# Elevation QA Report

**Project:** Washtenaw Co. MI-GPSC re-delivery

# Elevation QC Review Report

**Project:** Wayne Co. MI - GPSC      **Contractor:** Woolpert

Example # 2-4

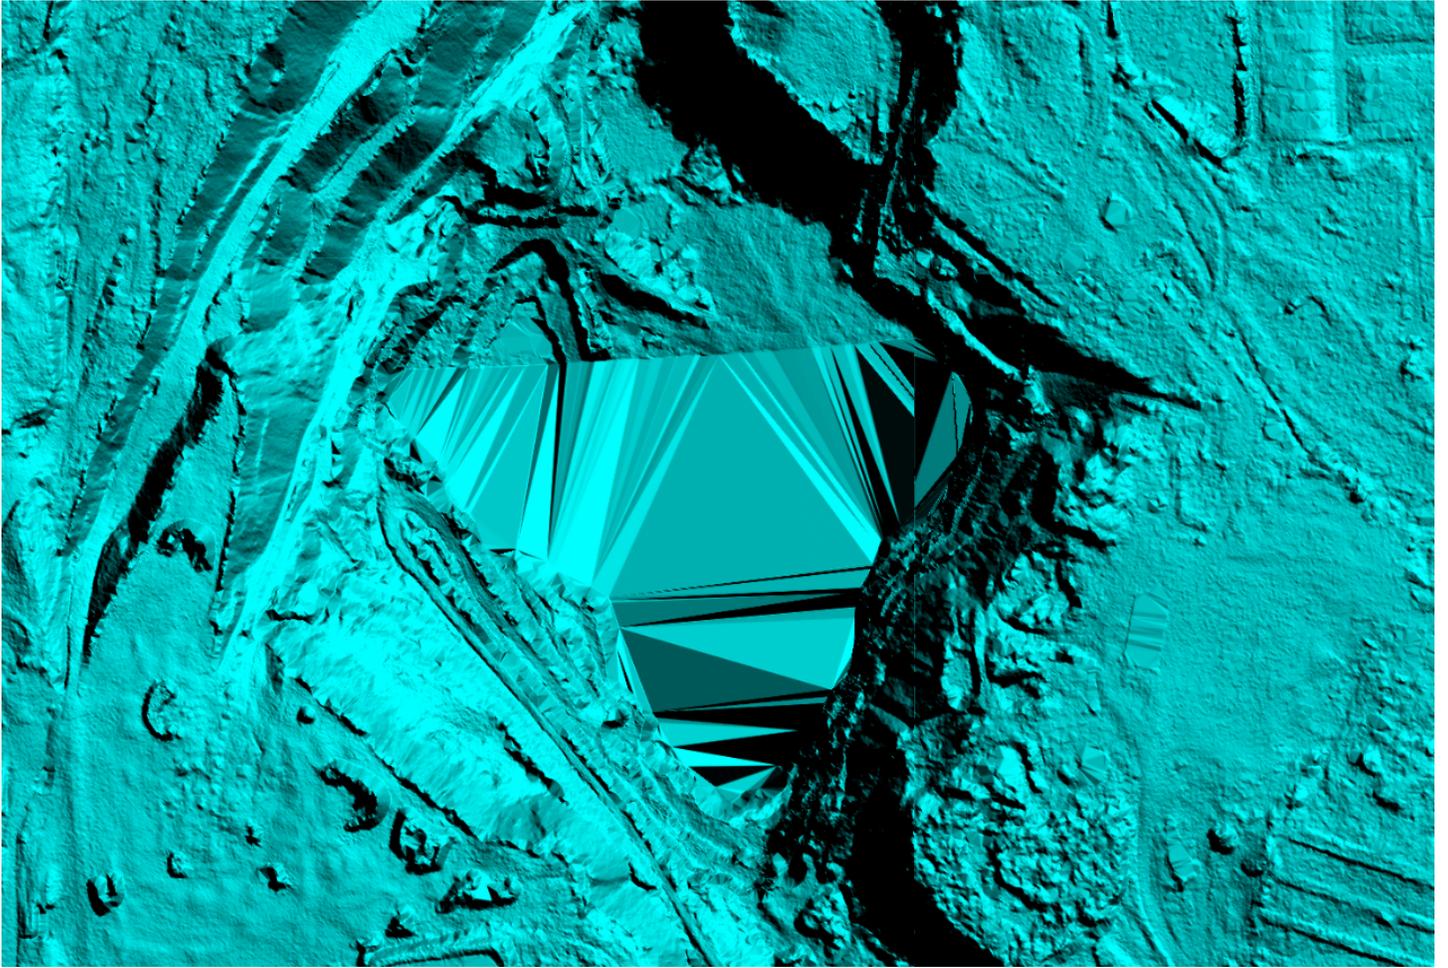
Wayne Co. does not require hydro-flattening. See the Teleconference Notes attached. Five areas of missing data were found. See all examples on following pages.
